Summit County Planning Commission (SCPC)
Thursday, August 28, 2025 - 3:00 p.m.
County of Summit, 470 Grant Street Building
470 Grant Street, 2nd Floor, Akron, Ohio
Meeting Agenda

Planning Commission
Concept Plan
Farmdale Plat
Springfield Township

EXECUTIVE SUMMARY

BOUNDARY SURVEY

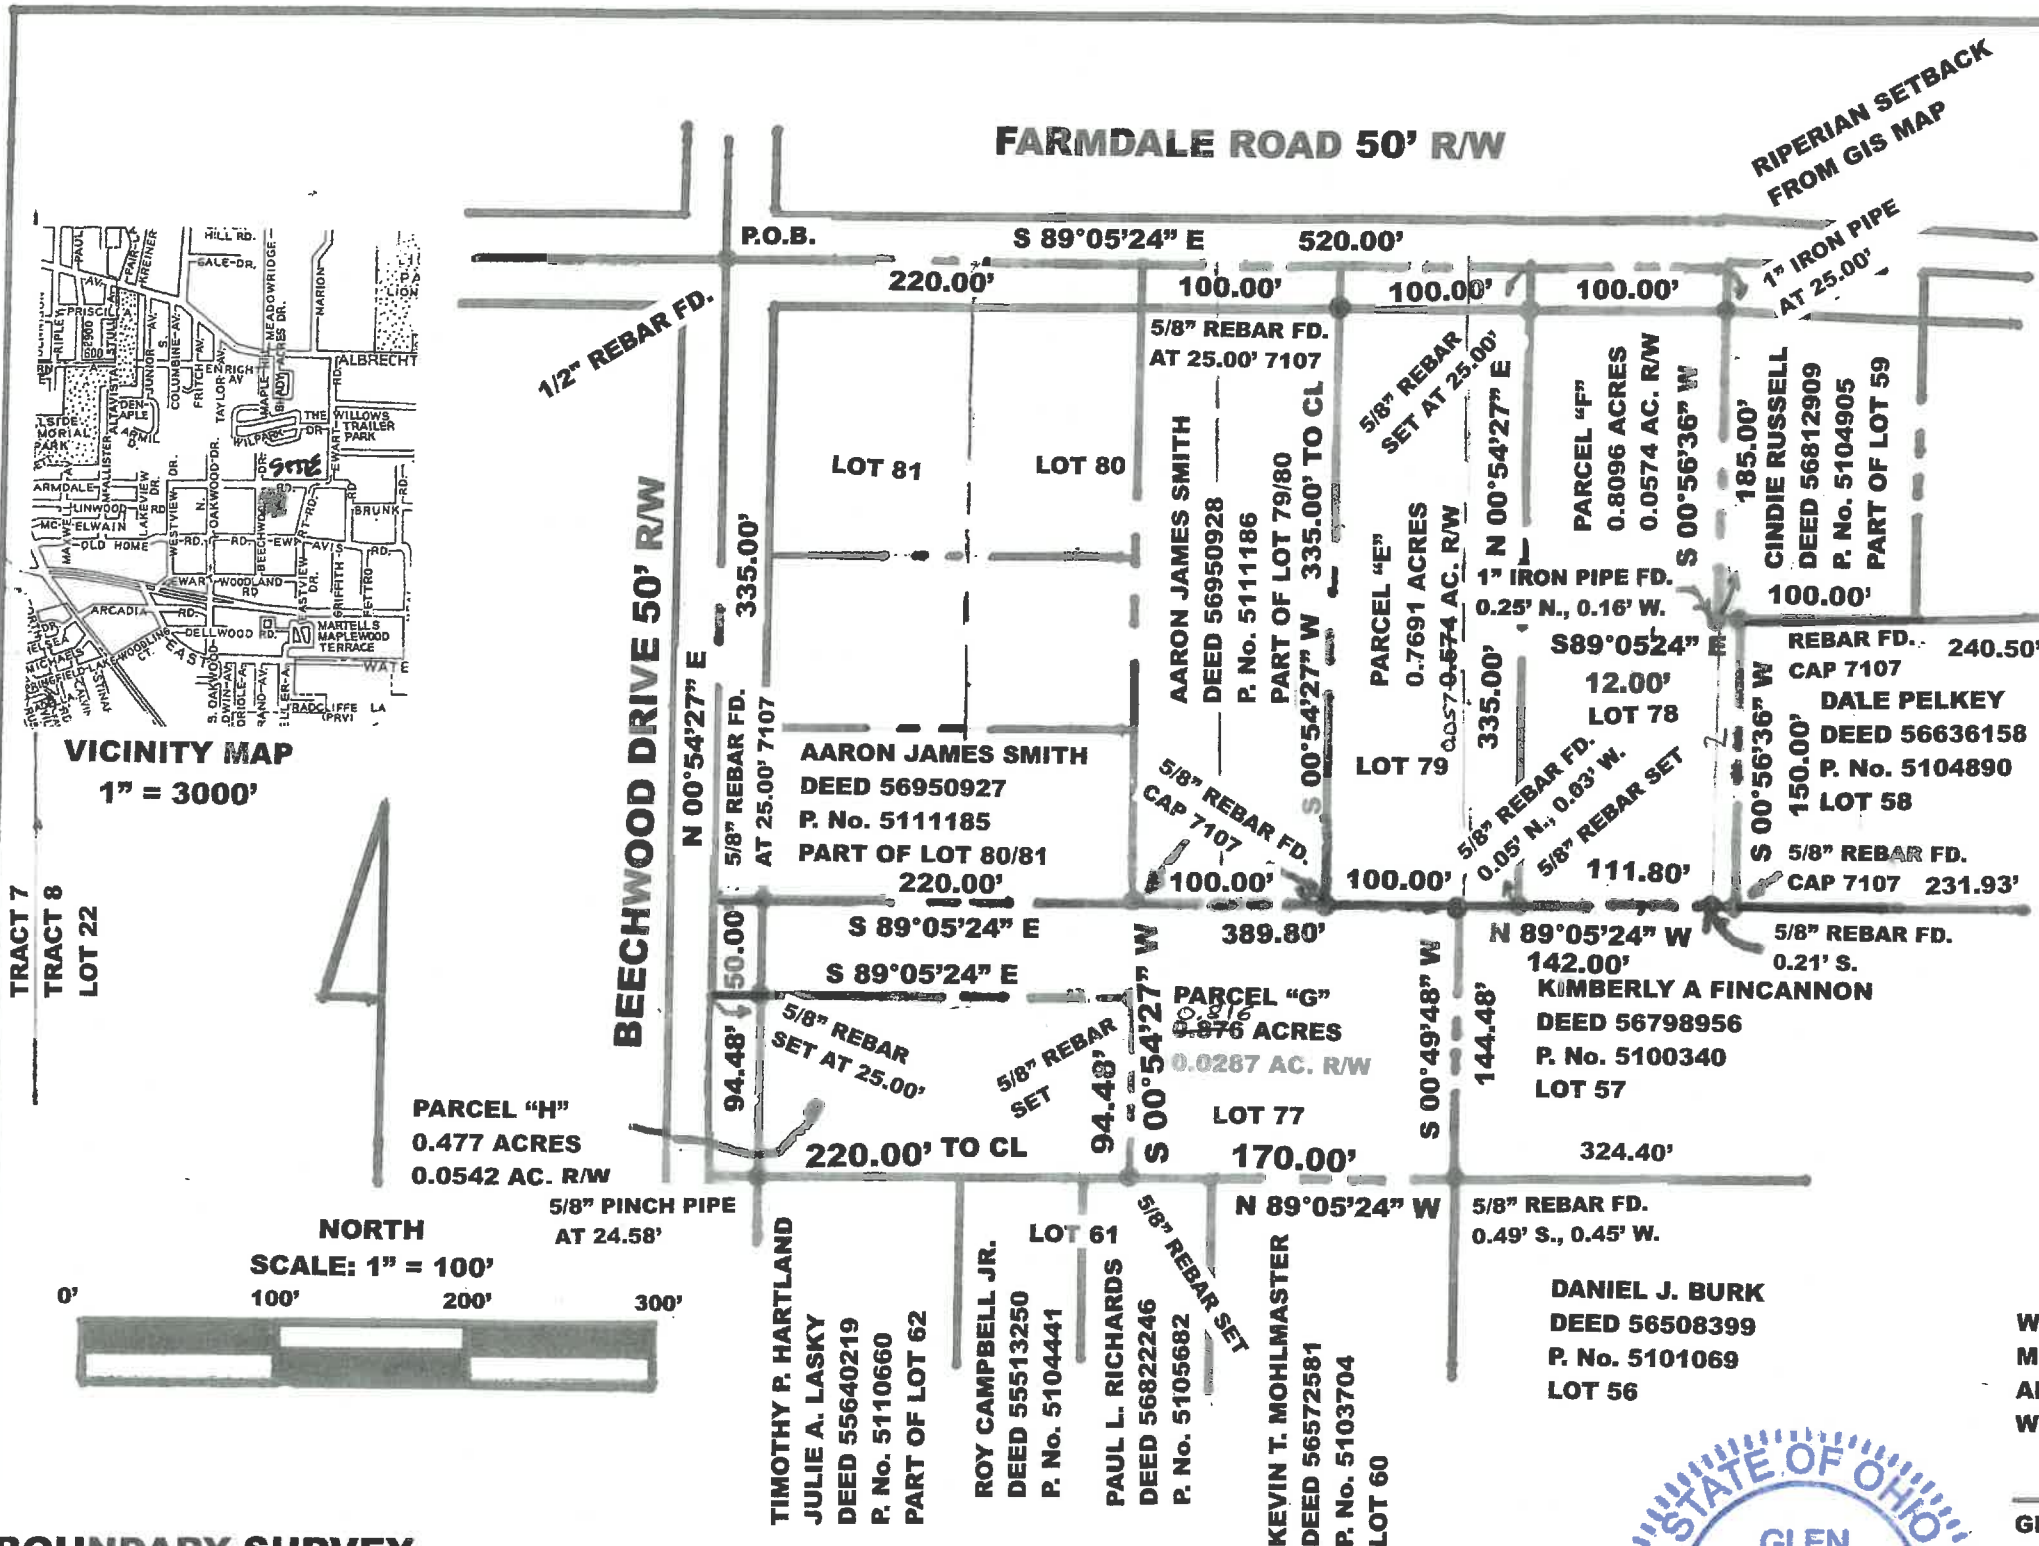
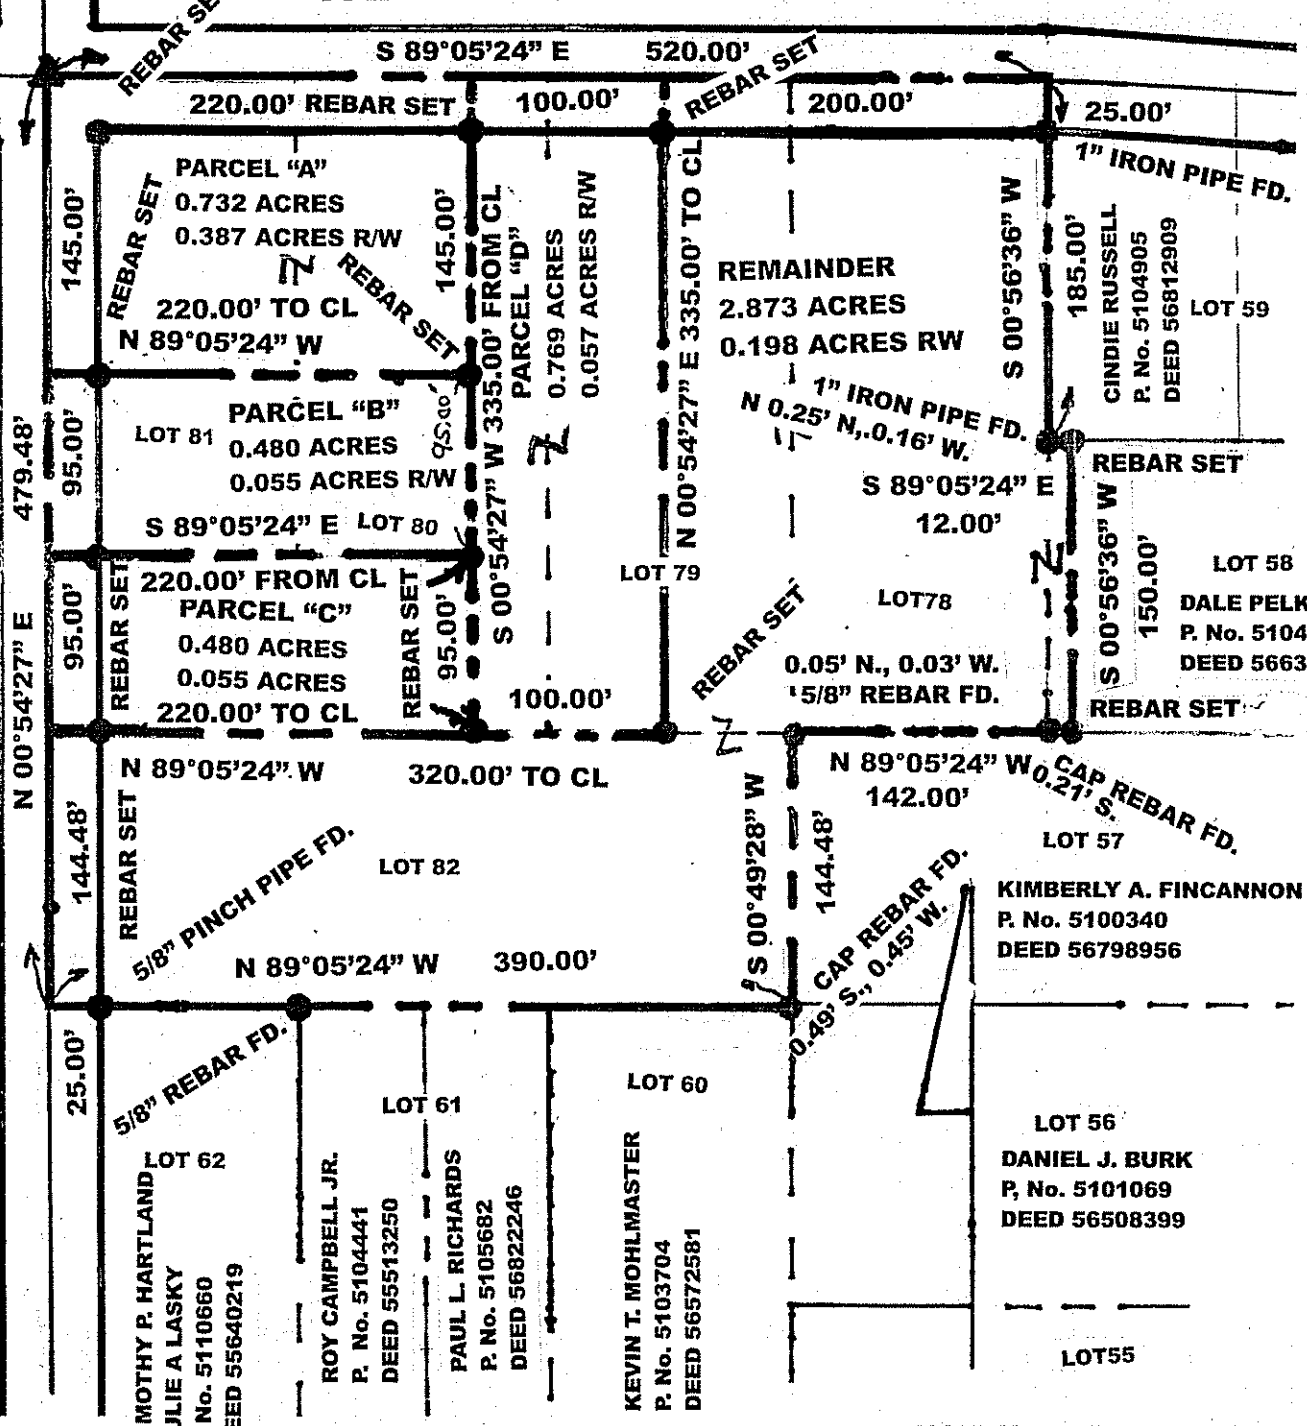
1. *Stormwater Calculations must be submitted for the Site...a runoff comparison (Proposed Development vs Previous School Site) must be completed. Should the runoff indicate an increase for the Proposed Site, all Stormwater Management for the Site must follow the SCE Stormwater Drainage Manual, Current Edition (Revised 1/1/20). All SWM Facilities must be located outside of Riparian Setbacks and are to be in Blocks or Open Spaces along Public Roads. In addition, the outlet pipe for the proposed SWM Basin must have an adequate outlet.*

2. *Should a SWM Facility be required, a 100-Year Overland Flow Path across the site to the SWM Facility must be present. When the flow path is located outside of the R/W, it must be centered in a minimum 30' wide SWM Easement.*

3. *If 1-Acre or greater of earth disturbance will be occurring, Water Quality with an LTMA will be required.*
4. *GIS indicates a Riparian Setback is present on the Site and therefore needs to be identified.*

6. *A Traffic Impact Questionnaire for the project must be completed to determine if additional Studies are warranted.*
7. *How will utilities (Sanitary, Water, Storm, Gas, Electric, etc...) be accessed. Should a road crossing be necessary, will the Township require the road to be bored (vs Open Cut)?*

-
9. *A Road Opening Permit will be required for any proposed work within the Existing R/W of Farmdale Road & Beechwood Drive.*

- I compared the hardscape condition of the previous school site to the proposed development (files attached). With a greater than 50% reduction of hardscape and no planned grade modifications, the ground infiltration will be improved and runoff will be reduced.

- Traffic Impact Questionnaire attached, included sources of calculated data.

Exhibit H

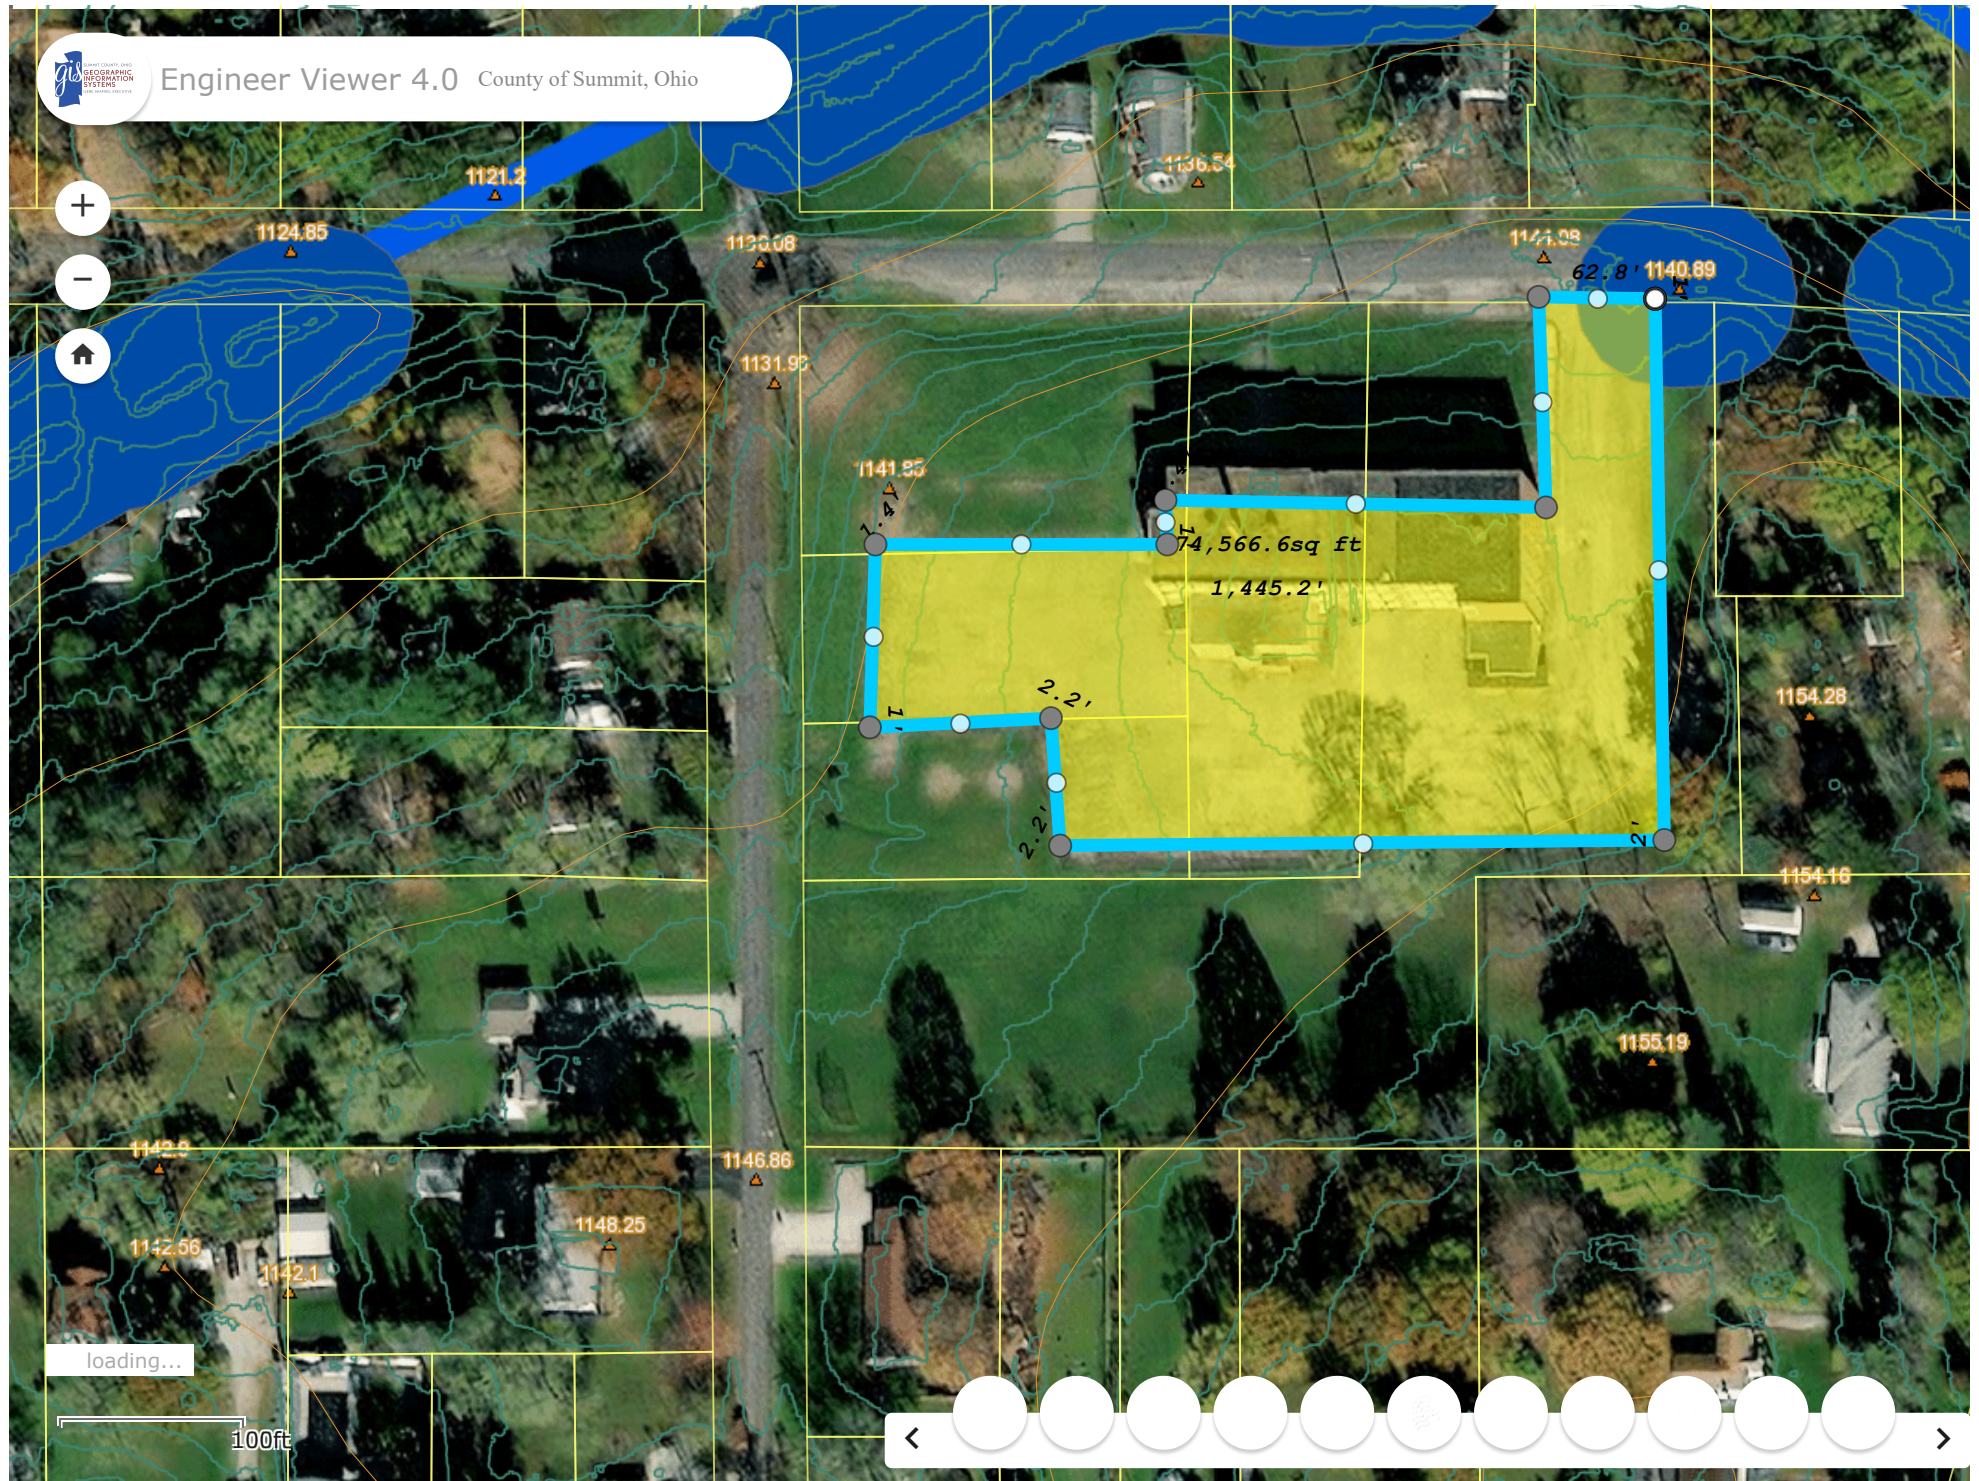
1. Stormwater Calculations must be submitted for the Site...a runoff comparison (Proposed Development vs Previous School Site) must be completed. Should the runoff indicate an increase for the Proposed Site, all Stormwater Management for the Site must follow the SCE Stormwater Drainage Manual, Current Edition (Revised 1/1/20). All SWM Facilities must be located outside of Riparian Setbacks and are to be in Blocks or Open Spaces along Public Roads. In addition, the outlet pipe for the proposed SWM Basin must have an adequate outlet.

- Assumptions:
 - Each Home: ~ 2000 SF (40'x50').
 - $8 * 2000 = 16,000$ SF
 - Driveways: Zone R-2 requires minimum 40' long. Assume 60' long x 20' wide concrete. ~1200 SF. Assume the driveway on the flag lot will be approximately 200' long.
 - $7 * 1200 = 8400$ SF
 - $1 * 4000 = 4000$ SF
 - Total Driveways = 12,400 SF
 - Contingency = 10% other hardscape.
 - $(16,000 + 12,400) * 0.1 = 2,840$ SF
 - Total proposed hardscape area = 31,240 SF / 43,560 SF/Acre = 0.72 Acres

Conclusion: Hardscape will be reduced by more than half, resulting in improved ground infiltration, and subsequently reduced runoff.
